Service Bulletin

No. : MZ08-US01

Model: SR4002, SR5002, SR7002, SR8002

Subject: Reset Procedure

SR8002, SR7002:

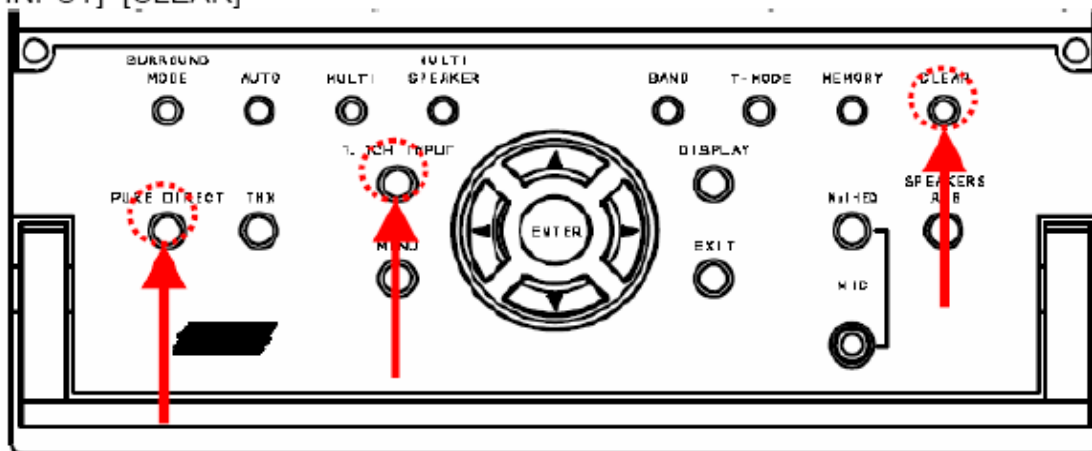
Symptom: These units have been modified to never be powered ON by any means once they go into standby with the standby led flickering every 125m sec., unless the specialized procedure (*1) described below is performed.

Solution: *1: If the unit cannot be powered on after being plugged in again (with the STANDBY LED flickering every 125m seconds), the power amp has failed. The unit still can be powered on again through the following method, but it can further damage the power amplifier. Please never let end-users perform this procedure.

Can be powered on by "FACTORY KEY" = [PURE DIRECT]+[7.1 CH INPUT]+[CLEAR]
